SUNDRY NOTICES AND REPORTS ON WELLS
Do not use this form for proposals to drill or to re-enter an abandoned well. Use Form 3160-3 (APD) for such proposals.

8. Well Name and No.
Frontier A #1 **MAY 02 2016**

PLUG AND ABANDONMENT PROCEDURE

CONDITIONS OF APPROVAL

Proposed P&A

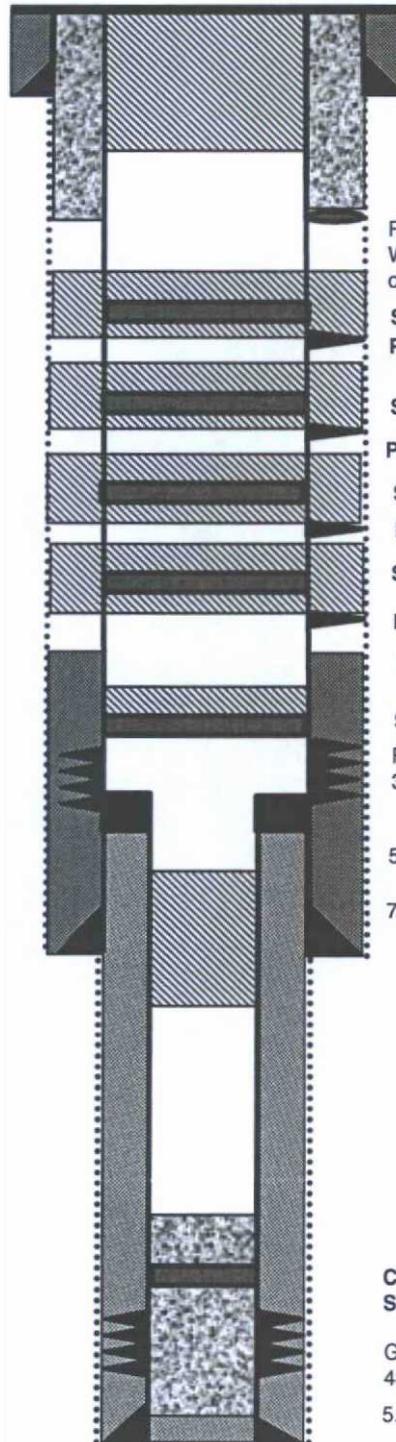
1. Plugging operations authorized are subject to the attached "General Requirements for Permanent Abandonment of Wells on Federal and Indian Lease."
2. Farmington Office is to be notified at least 24 hours before the plugging operations commence (505) 564-7750.
3. The following modifications to your plugging program are to be made:
 - a) Set a Plug #3 (2074-1974) ft. inside/outside to cover the Mesaverde top. BLM picks top of Cliff House at 2024 ft.
 - b) Bring the top of Plug #6 to 824 ft. inside/outside to cover the Fruitland top. BLM picks top of Fruitland at 874 ft. Adjust cement volume accordingly.

Operator must run a CBL to surface to identify TOC. Submit the electronic copy of the log for verification to the following addresses: jwsavage@blm.gov Brandon.Powell@state.nm.us

You are also required to place cement excesses per 4.2 and 4.4 of the attached General Requirements.
